# Access Compliance Report

## Public Rights-of-Way

### (Curb Ramps)

Intersection ID: 10011741	Main Street: N_SHARON_AMITY_RD	Cross Street: N/A	Location: NE
ADA ID: CACAEC2FBEF3	Ramp Type: PerpDiag	Initial Pass/Fail: Fail	Overall Compliance: No
Severity Score: 22.5			
Codes/Mitigation Info/Possible Solution		Field Measurements/Component Compliance

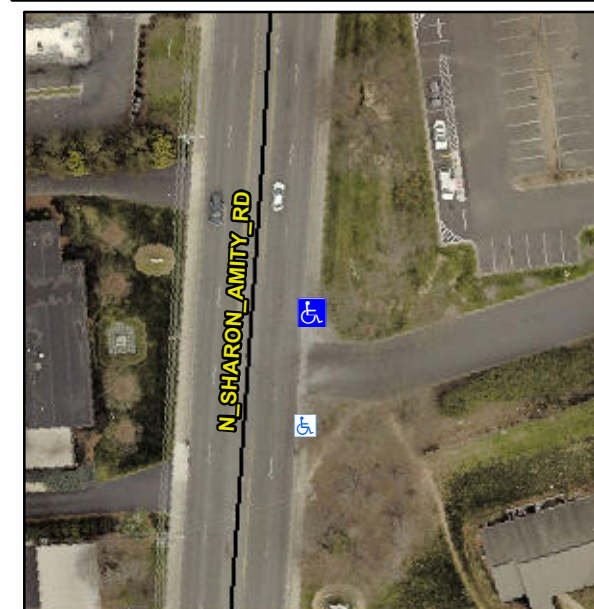
**Not Found, R304.5.1, R304.2.2, R304.5.3**

Compliance	Description	Data	Compliance	Description	Data
N/A	Ramp Length (in)	60.0	No	Ramp Slope (%)	10.8
No	Ramp Width (in)	44.0	No	Ramp XSlope (%)	3.2
N/A	Flare Type LT	N/A	N/A	Flare Type RT	N/A
N/A	Flare Slope LT (%)	N/A	N/A	Flare Slope RT (%)	N/A
N/A	Flare Traversable LT?	N/A	N/A	Flare Traversable RT?	N/A
N/A	Landing Length (in)	N/A	N/A	DWS Provided?	N/A
N/A	Landing Width (in)	N/A	N/A	DWS Contrast?	N/A
N/A	Landing Slope (%)	N/A	N/A	DWS Length (in)	N/A
N/A	Landing X Slope (%)	N/A	N/A	DWS Full Width?	N/A
N/A	Landing Curb? (Y/N)	N/A	N/A	DWS Offset (in)	N/A
N/A	Shared Landing?	N/A			
N/A	Gutter Ponding?	N/A	N/A	Gutter Slope (%)	N/A
N/A	Gutter Lip Ht (in)	N/A	N/A	Gutter X Slope (%)	N/A
N/A	Painted X Walk1?	No	N/A	Painted X Walk2?	No
	X Walk 1 Direction	To W		X Walk 2 Direction	To S
N/A	X Walk 1 Width (in)	N/A	N/A	X Walk 2 Width (in)	N/A
	X Walk 1 Slope (%)	2.5		X Walk 2 Slope (%)	1.0
	X Walk 1 X Slope (%)	0.4		X Walk 2 X Slope (%)	2.1

**Remove & Replace Curb Ramp With Two New Directional Ramps or Equivalent.**
